# UNITED STATES PATENT AND TRADEMARK OFFICE

10/598,008

<b>Office Action Summary</b>	<b>Application No.</b> 10/598,008	<b>Applicant(s)</b> FELBER, JOSEF	
	<b>Examiner</b> ELIZABETH VOLZ	<b>Art Unit</b> 3781

## **DETAILED ACTION**

**Figure 15 (Robichaud et al.)**

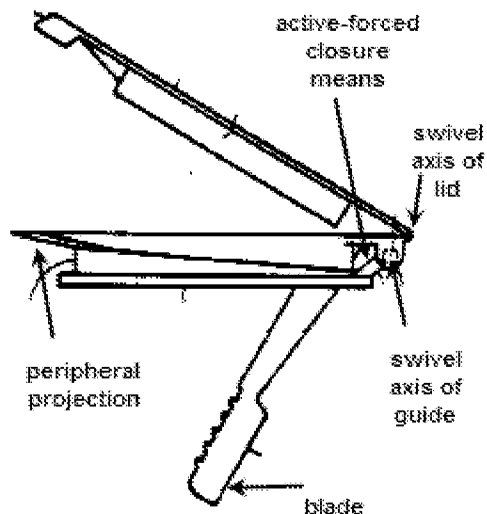
5. Claims 11, 12, 14, 17 and 21 are rejected under 35 U.S.C. 102(b) as being anticipated by Robichaud et al. (U.S. Patent No. 4,934,590).
6. Regarding Claim 11, Robichaud et al. discloses a flap shutter for combo and carton packaging for automatic opening of a packing by opening a closure lid, comprising: a frame base element 102 (Figure 14) having a flat bottom side for connecting with a combo or carton packing (Figure 12), said frame base element further

including a peripheral projection (Figure 15 below) projecting upwardly for forming an outflow support opening within said frame base element; a lid 14 (Figure 15) connected to, and swiveling on, said frame base element for closing the out-flow support opening formed by said frame base element (Figure 14) and for opening and closing said frame base element; a guide element 106 (Figure 15) capable of swiveling on said frame base element extends over an inner side of said peripheral projection with a swivel axis of said guide element (Figure 15 below) running parallel to, and in front of, a swivel axis of said lid (Figure 15 below); active forced-closure means (Figure 15 below) located between said guide element and said lid for allowing said guide element to be swiveled downwardly by opening said lid for cutting, tearing or pushing downwardly a packing lying below said guide element in a swiveling direction opposite a swiveling direction of said lid (Column 6, Lines 49-52), so that when seen in a side view, said lid swivels in a first direction and said guide element swivels in a second direction (Figure 15), said second direction being a direction opposite said first direction (Figure 15).

7. Regarding Claim 12, Robichaud et al. discloses a lid 14 (Figure 1) which is placed and held on said frame base element in a swiveled-up position via a first swivel shaft 128 (Figure 15) and said guide element is placed and held in a swiveled-down position on said frame base element via a second swivel shaft 128 (Figure 15) running parallel to a direction of a swivel region of said lid.

8. Regarding Claim 14, Robichaud et al. discloses a lid 14 (Figure 15) has a top side that tangentially merges in said first swivel shaft (Figure 15) and said guide element has a top side (Figure 15) that tangentially merges in said second swivel shaft, so that a bottom side of said lid lies substantially on a top side of said guide element in a swiveled-down mode on said base element (Figure 14), and a marginal region of said guide element forms a blade (Figure 15 above) projecting downwardly, so that a downwardly projecting piercing tip is formed at a tip of said guide element (Figure 15).

9. Regarding Claim 17, Robichaud et al. discloses a lid 14 (Figure 15) which is placed and held in a swiveling position on said frame base element via a first swivel shaft (Figure 15) and said guide element is placed and held in a swiveled-down position on said frame base element via a second swivel shaft running parallel to a direction of a swivel region of said lid (Figure 15), said first swivel shaft and said second swivel shaft being formed with tilt plate bolts at their ends 124/126 (Figure 15).

10. Regarding Claim 21, Robichaud et al. discloses a frame base element 102 (Figure 15) including inward projections 138 (Figure 10) formed on a side of said frame base element extending over said guide element for forming a stopper, so that said guide element is swivelable only downwardly from said frame base element (Column 6, Lines 59-61).
